Kuliouou Beach Park  
Imp.

Subject: Finding of No Significant Impact  
Kuliouou Beach Park Improvements  
Honolulu, Hawaii (TMK: 3-8-03:32)

\*\*\*\*\*  
**FINAL**  
**ENVIRONMENTAL**  
**ASSESSMENT**  
 \*\*\*\*\*

***Kuliouou***  
***Beach Park***  
***Improvements***

EXISTING COMFORT STATION RENOVATION FLOOR PLAN

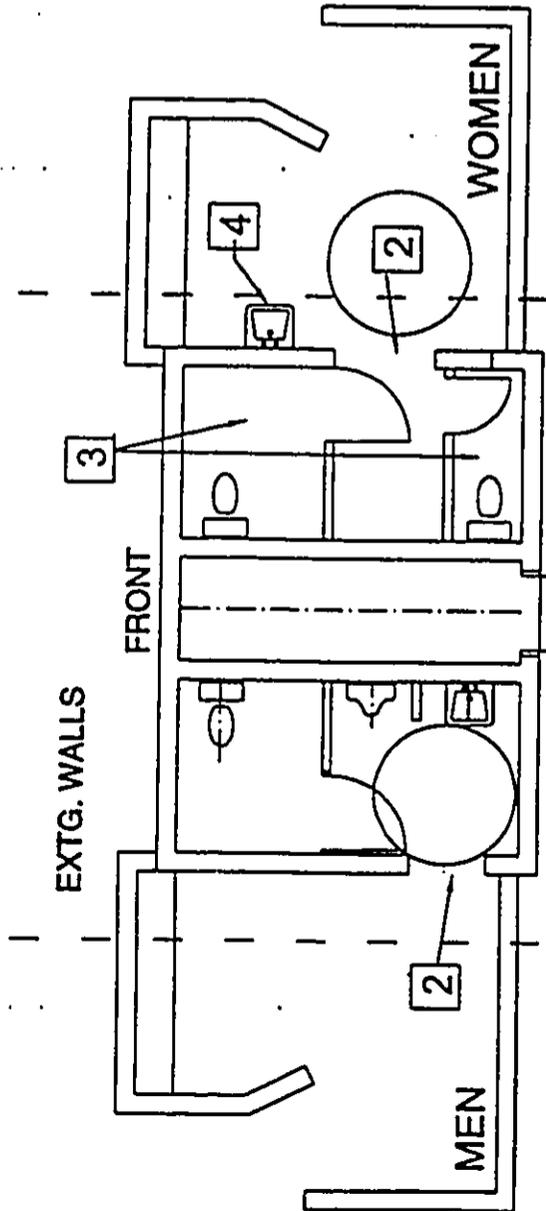
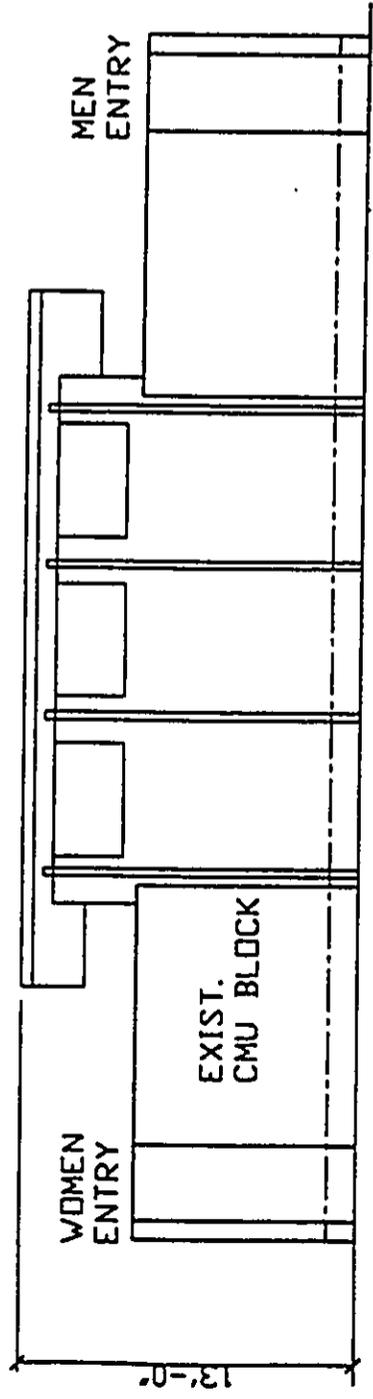
19. Exhibit 9:  
The title of the exhibit should be revised to indicate that it is a proposed comfort station design.
  20. Exhibit 11:  
This site plan, or an additional site plan exhibit, should indicate the location of the proposed replacement comfort station and any impacts that location may have on the proposed configuration of the parking lot.

7. The FEA will contain preliminary architectural plans for the comfort station renovation to include information regarding the height of the structure.

Exhibit 11

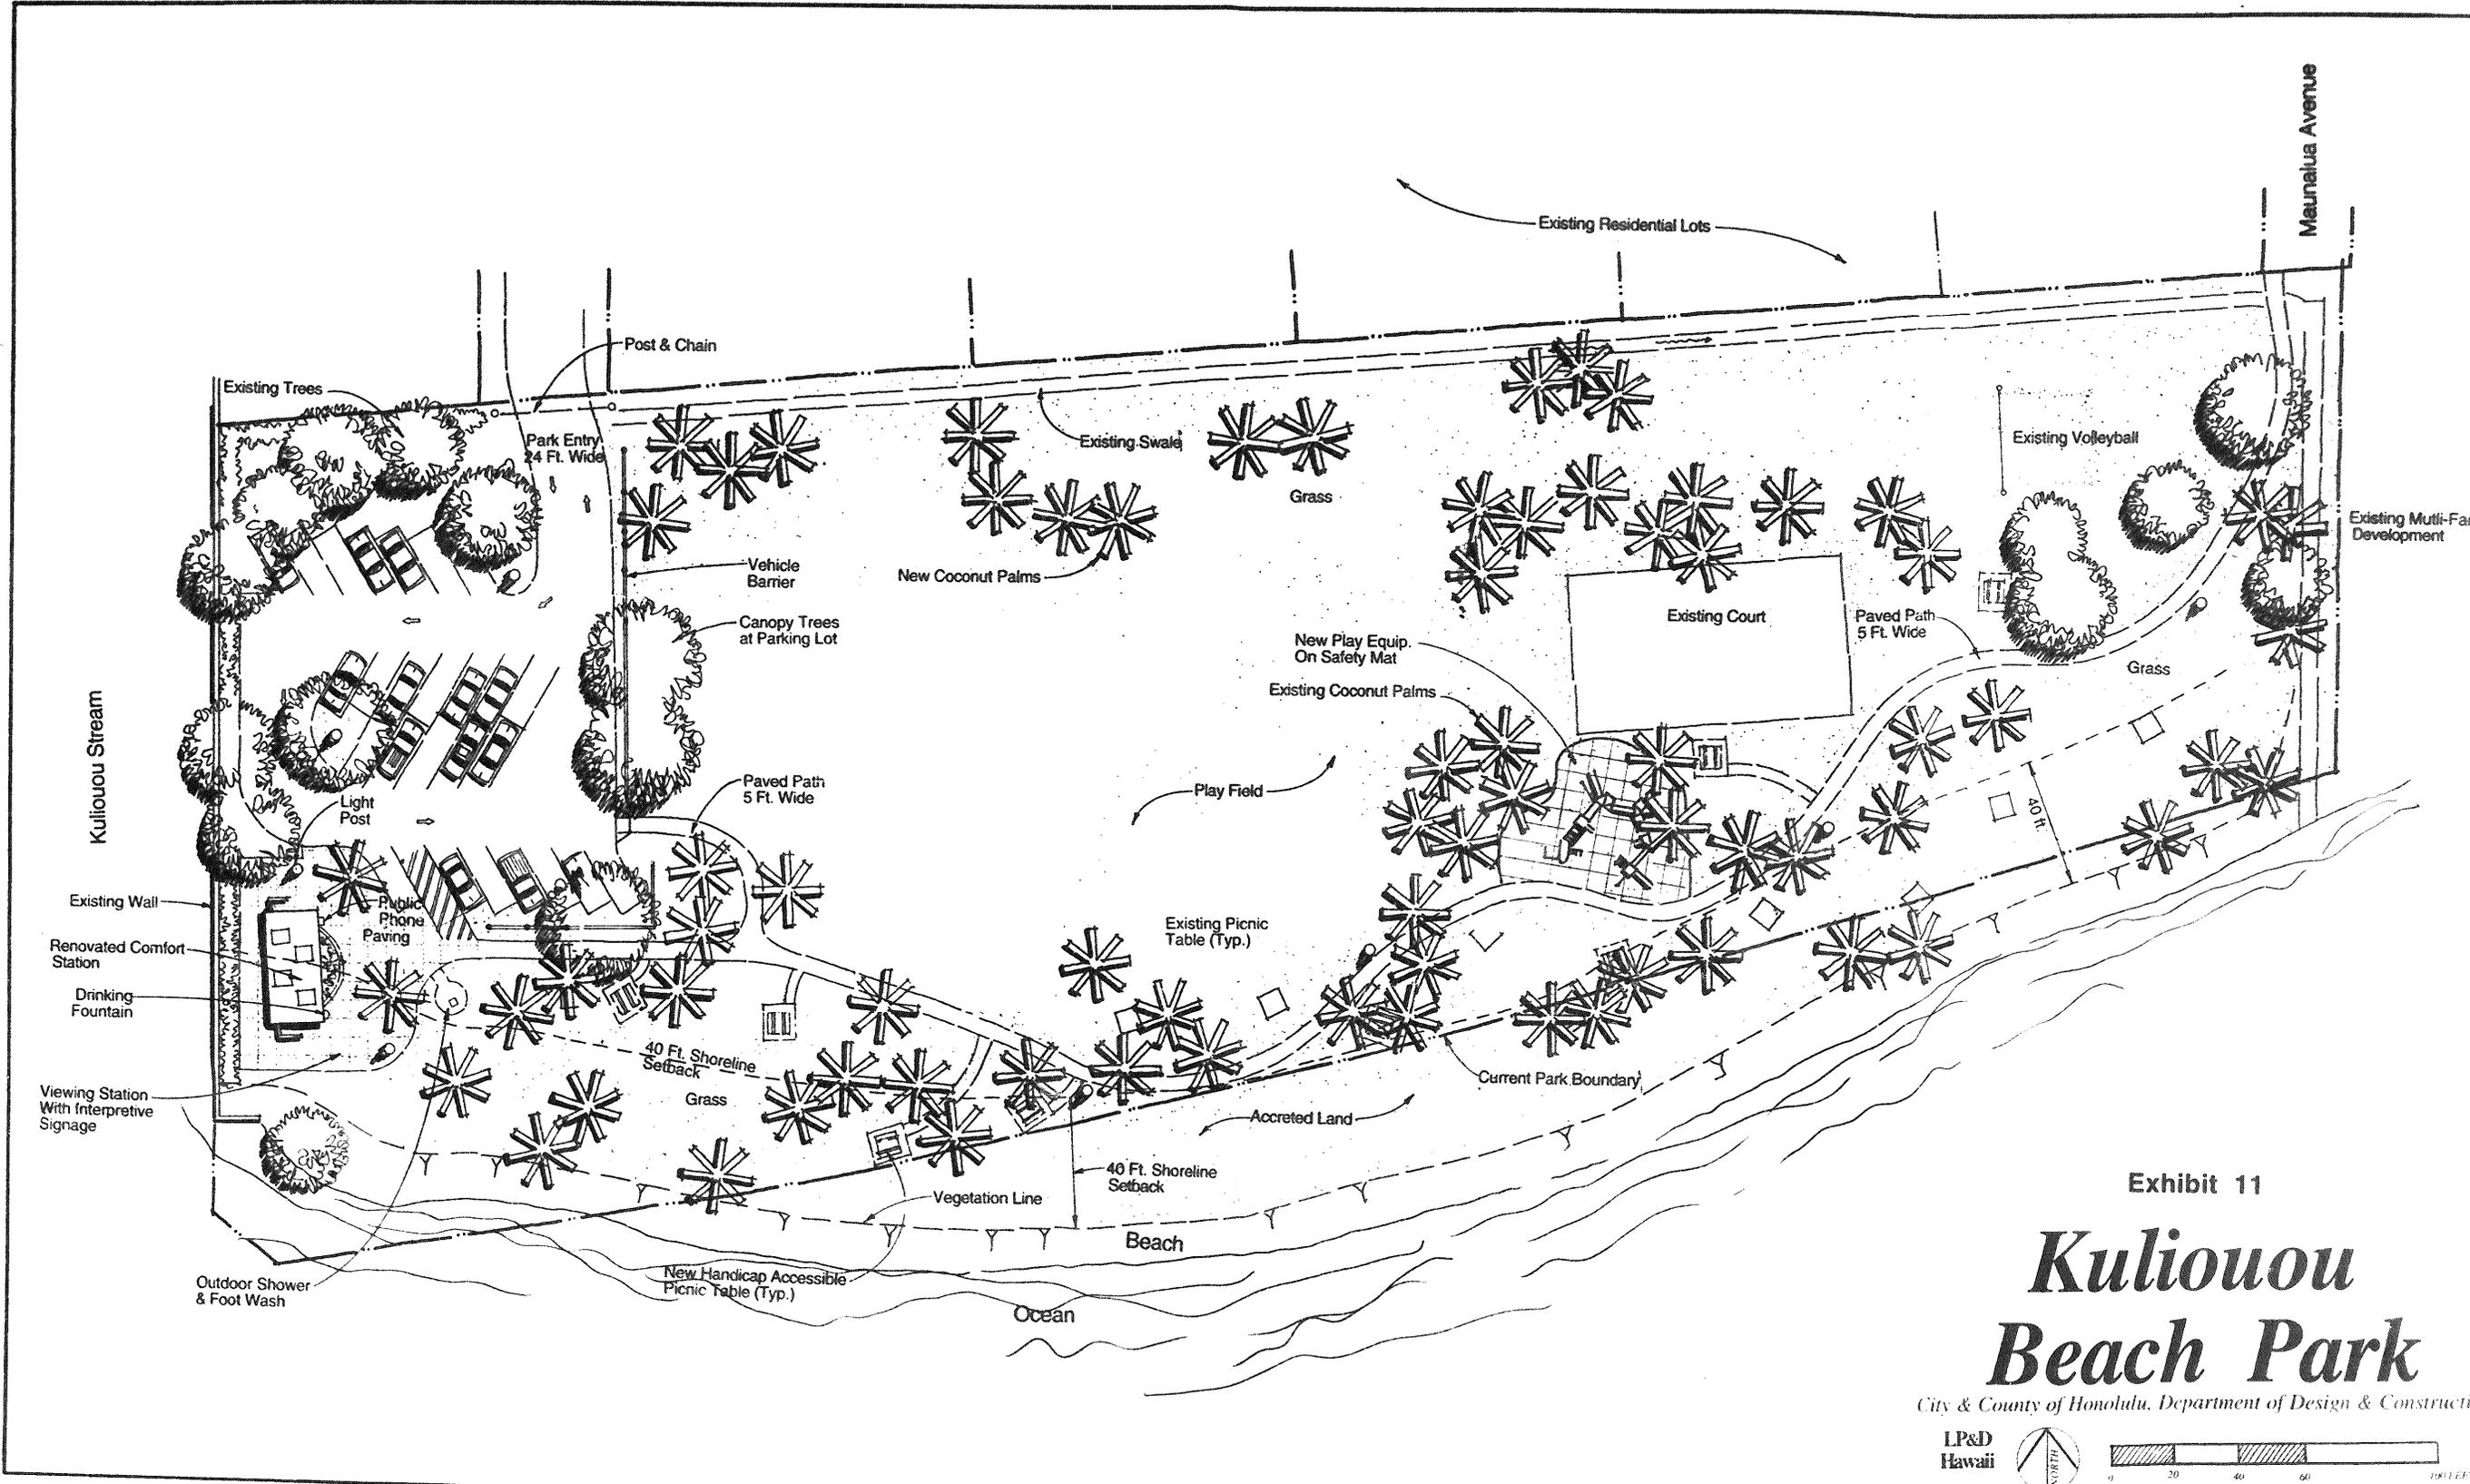
4. Sec. 2.3, 16th paragraph (pg. 2-6):  
The DEA indicates that the new pathway will provide handicap accessibility to all new picnic tables. Exhibit 11, proposed site plan, shows no connection between pathway and picnic tables. The FEA should resolve this discrepancy or discuss how this meets ADA requirements.

8. Page 2-6 of the Draft EA states that the proposed path will provide access to all picnic tables. Exhibit 11 does not clearly depict this. Please clarify this information.

4. The proposed concept plan will be revised to graphically indicate a connection between the 5 ft. pathway and the new picnic tables.
5. We are not aware of any nonpotable water supply system in the vicinity that is readily available for park irrigation.
